[1] REDLINE REVISION NO.1
1/27/2006
MODIFY SHIELD ASSEMBLY SIGN SIZE

MD 7A (REVOLUTION STREET) AND JUNIATA STREET

HAVRE DE GRACE, MARYLAND

TS NO. 1079 B | DRAWING NO. OF | SHEET NO. 1 OF 2

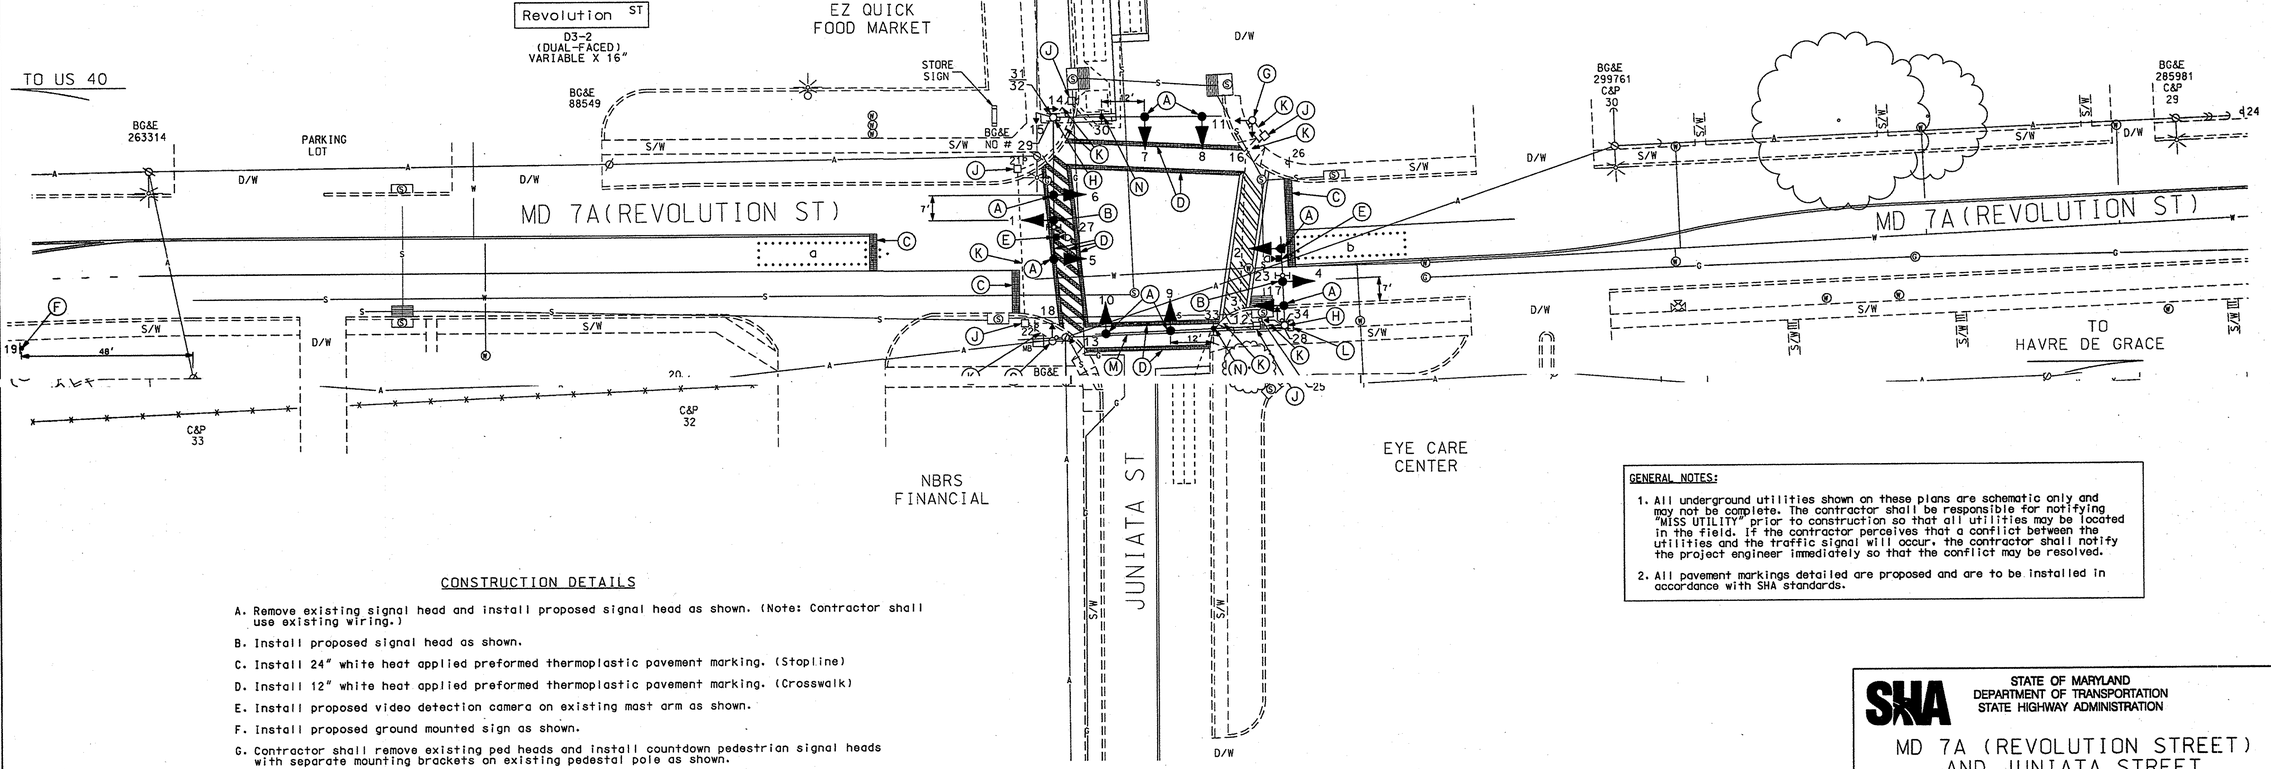
[1] 29 — WEST, MARYLAND 7 — M3-4 ~~30"x 15"~~ 24"x 12" — M1-5 ~~36"x 36"~~ 24"x 24" — M6-1 ~~30"x 24"~~ 21"x 15" — ASSOCIATED SHIELD ASSEMBLY ~~36" x 75"~~ 24" x 51"

[1] 34 — EAST, MARYLAND 7 — M3-2 ~~30"x 15"~~ 24"x 12" — M1-5 ~~36"x 36"~~ 24"x 24" — M6-1 ~~30"x 24"~~ 21"x 15" — ASSOCIATED SHIELD ASSEMBLY ~~36" x 75"~~ 24" x 51"
